**Re: wpd White Pines Wind Incorporated (the "Applicant")
EB-2013-0339**

System Impact Assessment Report (Addendum)

CAA ID: 2010-401
Project: White Pines Wind Generation Station
Applicant: White Pines Wind Farm Inc.

Date: July 21, 2014

Figure 1: Updated connection arrangement

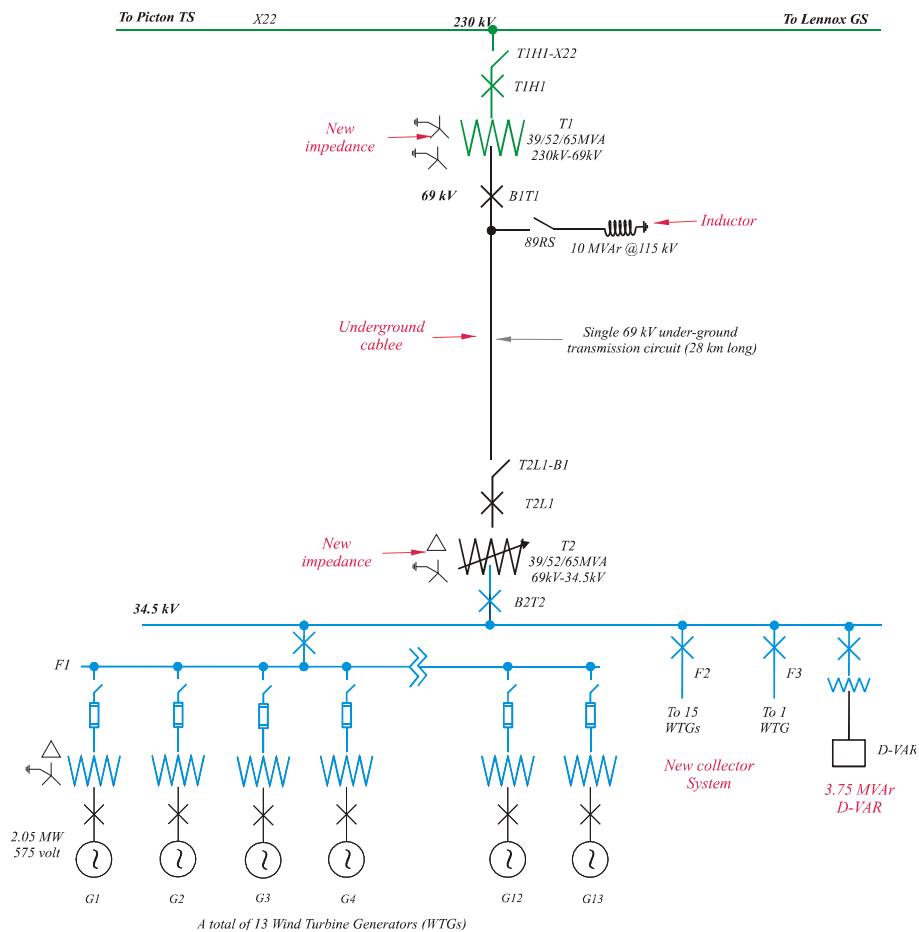
1. Install 28 km underground cable instead of overhead line for the 69 kV tap line;
2. Modify impedances for two step-up transformers (230/69 kV and 69/34.5 kV);
3. Modify the collector system design to use underground cables;
4. Install three collector feeders instead of two;
5. Install a 10 MVar @ 115 kV inductor at LV side of 230/69 kV transformer.

The updated connection arrangement highlighting the modified equipment is shown in Figure 1 below.

- (1) The project is required to have the capability to inject or withdraw reactive power continuously (i.e. dynamically) at the connection point up to 33% of its rated active power at all levels of active power output.

Based on the updated information on the 69 kV cable and collector system provided by the connection applicant, in addition to the requirement for the dynamic reactive power compensation, a static capacitive compensation device of 3 Mvar @34.5 kV installed at the White Pines Wind Farm would satisfy the reactive power requirement for the incorporation of the proposed project.

- (2) In order to have capability of injecting the required maximum reactive power to the system, the 69 kV system shall have maximum continuous operating voltage rating of 1.14 per unit (79 kV), or the 230/69 kV step-up transformer should be equipped with under load tap changers (ULTCs).
